Planning and Zoning Commission

May 4, 2022

TO: Planning and Zoning Commission
FROM: Molly Mannel, Assistant Planner
DATE: May 4, 2022
RE: Rocket Carwash – Site Plan

TO: Planning and Zoning Commission
FROM: Molly Mannel, Assistant Planner
DATE: May 4, 2022
RE: Herndon Property – Rezoning

Sheet 1 OF 3

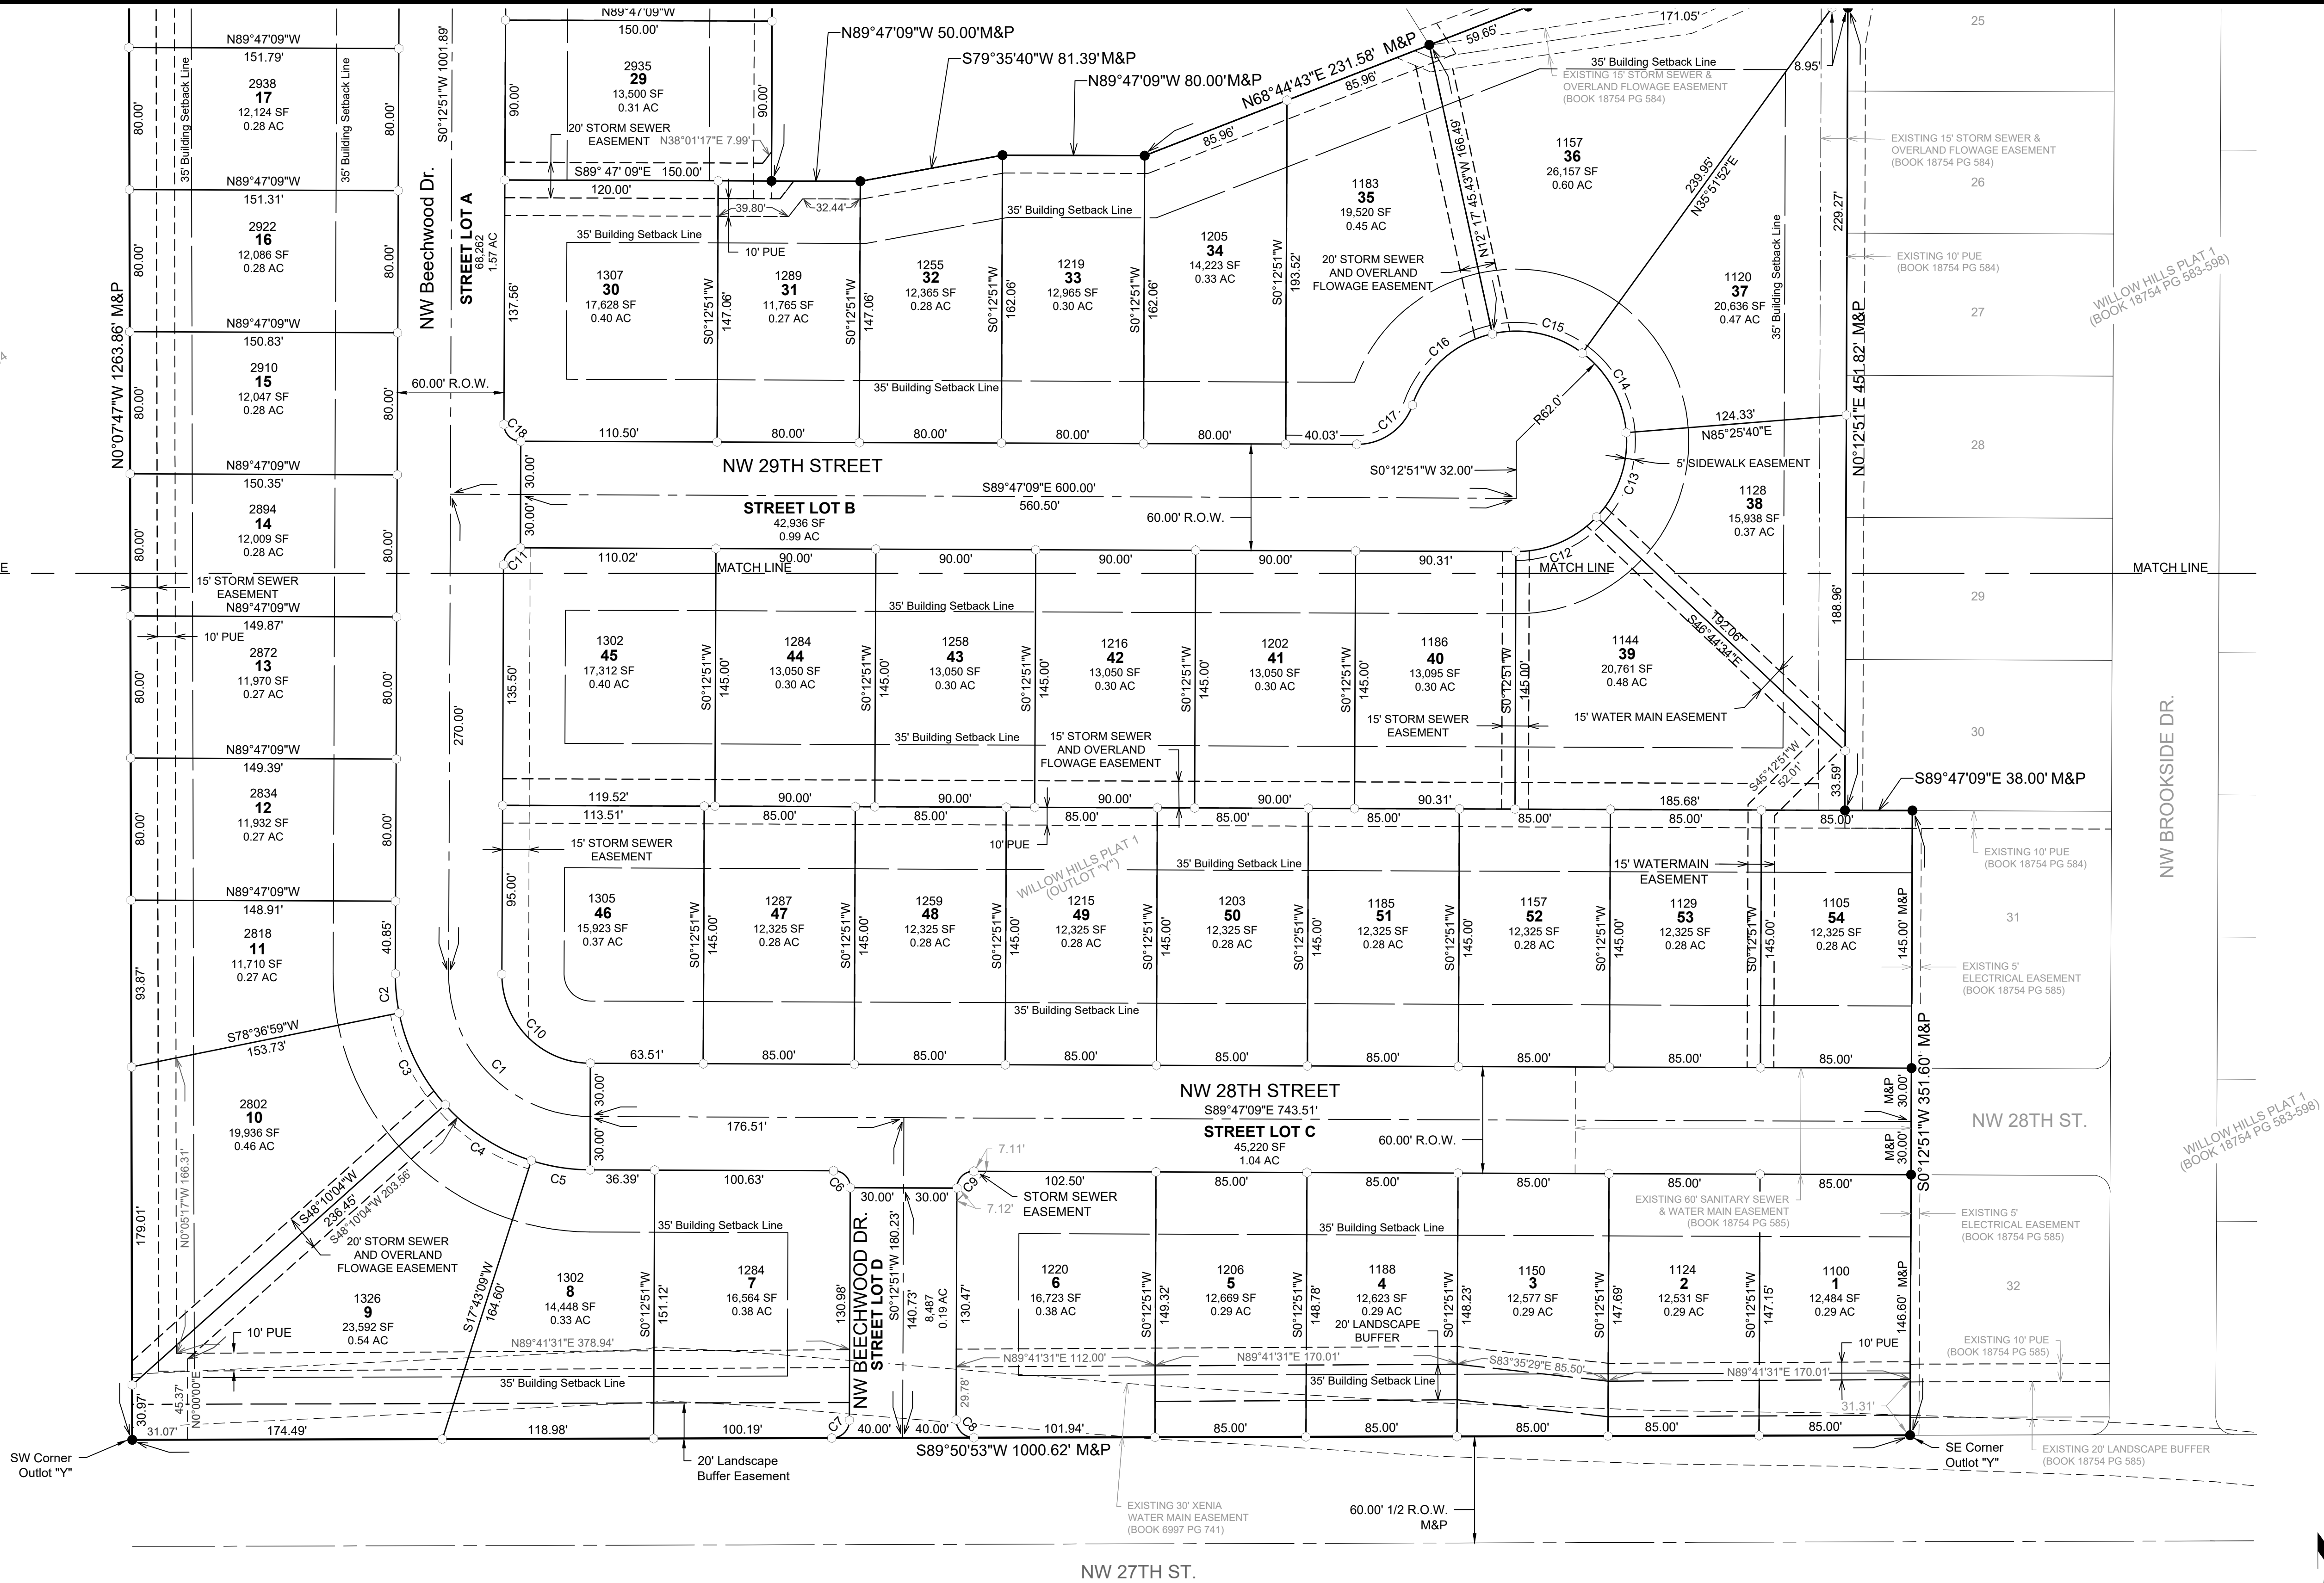
- ~~1. Provide final plat application and \$2000 review fee.~~
2. Provide MPE sheet. **Please provide.**
3. Label addresses for each lot. Addresses provided. **Please label both addresses for lot 30 and 45.**
- ~~4. Label rear building setback lines.~~
- ~~5. Revise street name of the north/south street. Should be NW Beechwood Drive.~~
6. Label the sanitary sewer easement at the end of NW Beechwood Dr. **Change label to "to be recorded by others"**
7. Label dimensions of the utility extension easement. **Change label to "to be recorded by others"**
- ~~8. Label the easement between lot 21/22 storm sewer and overland flowage.~~
- ~~9. Label the easement between lot 9/10 storm sewer and overland flowage.~~
- ~~10. Label the easement between lot 35/36 storm sewer and overland flowage.~~

12. The storm sewer easement along lot 45/46 does not match the construction drawings.
Please revise.

15. Revise NW 29th Street to Court

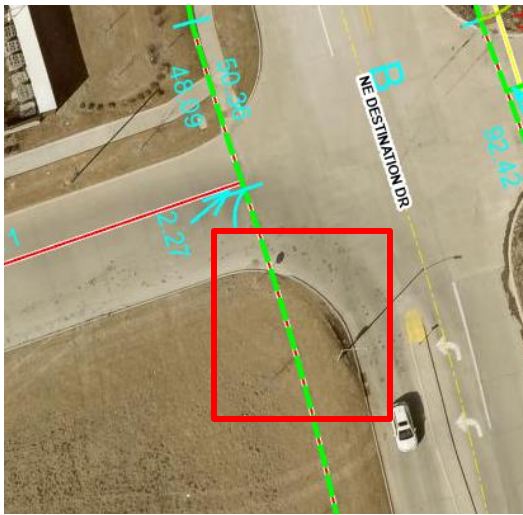
10. ~~Provide dumpster enclosure and vacuum equipment enclosures.~~
11. Label transformer location on all sheets. Has Mid-American approved the proposed location?
12. Please widen the entrance radius shown (red square). There have been occurrences where trucks are cutting into the ramping. Please view Starbuck's widening onto NE Destination Dr (yellow square) as an example.

Sheet C1.00

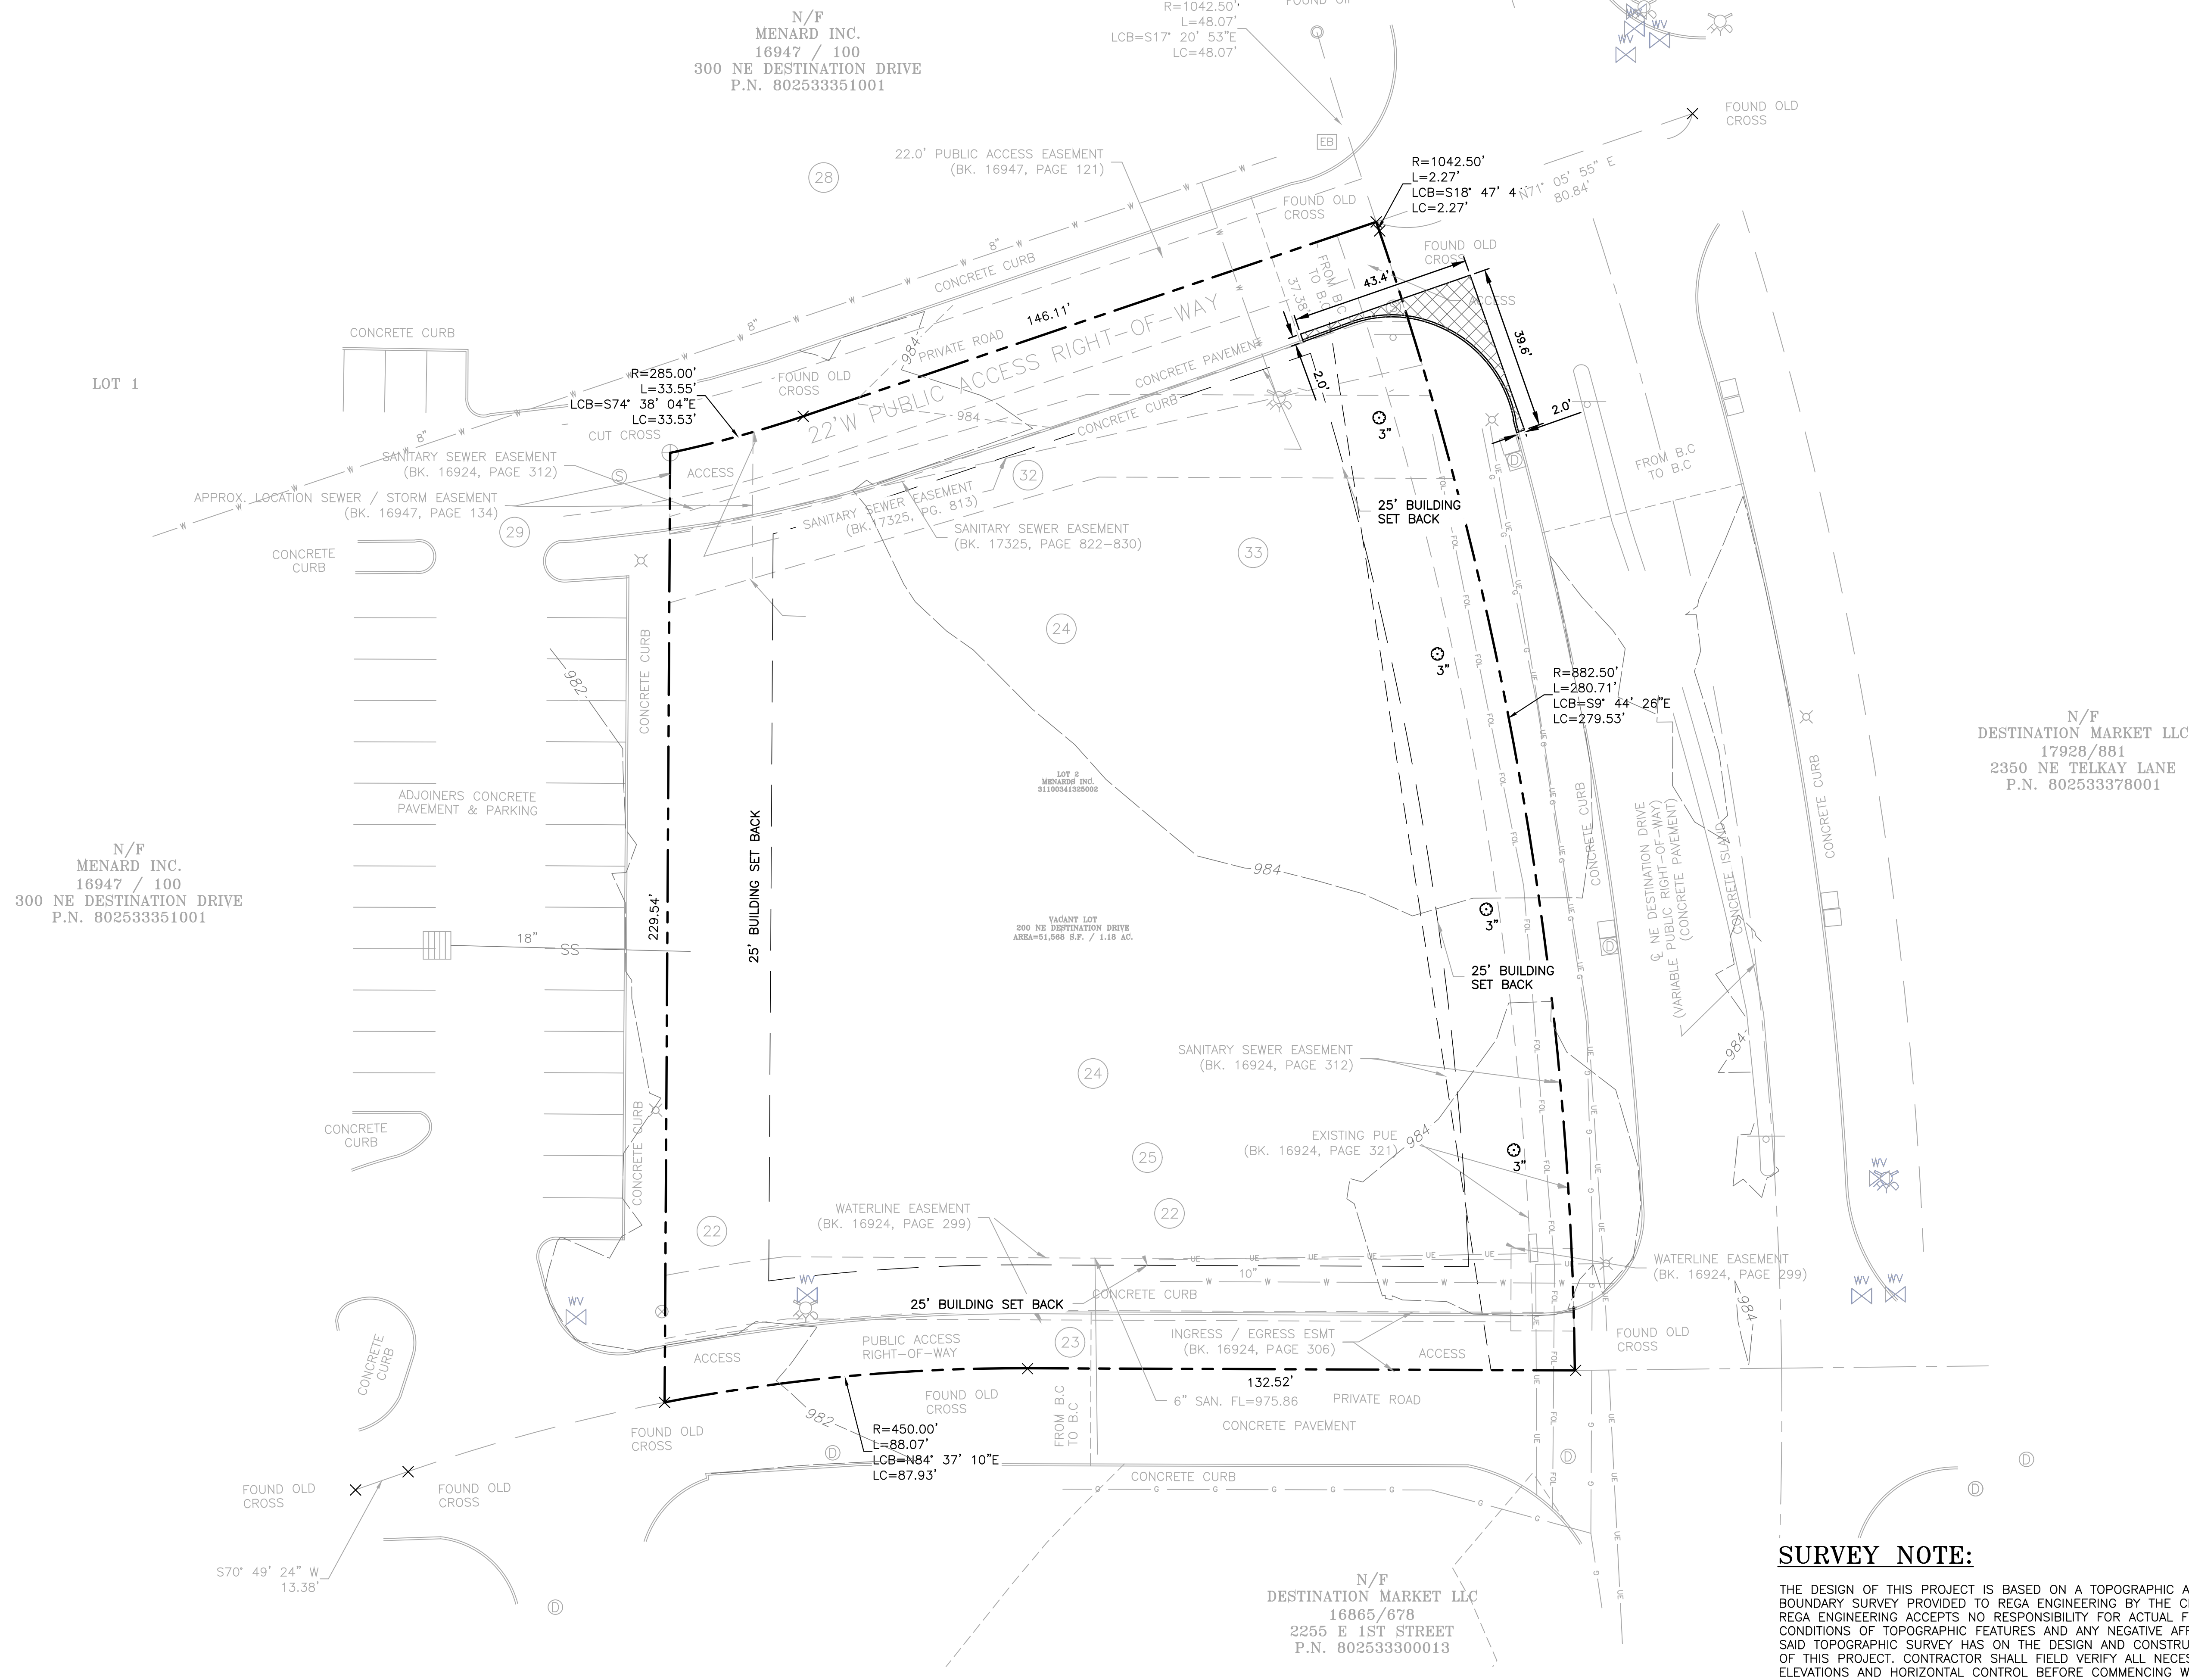
1. ~~Add Utility contacts.~~
2. ~~Specify that the property is within Zone 2 of the Highway 141 overlay district.~~
3. Update maximum site coverage within the Zoning Information Table. A minimum of 15% open space is required. **The PERCENTAGE OF REQUIRED GREEN SPACE provides the accurate minimum and proposed green space – please update the Min. Site Coverage row within the Zoning Information table with those percentages.**
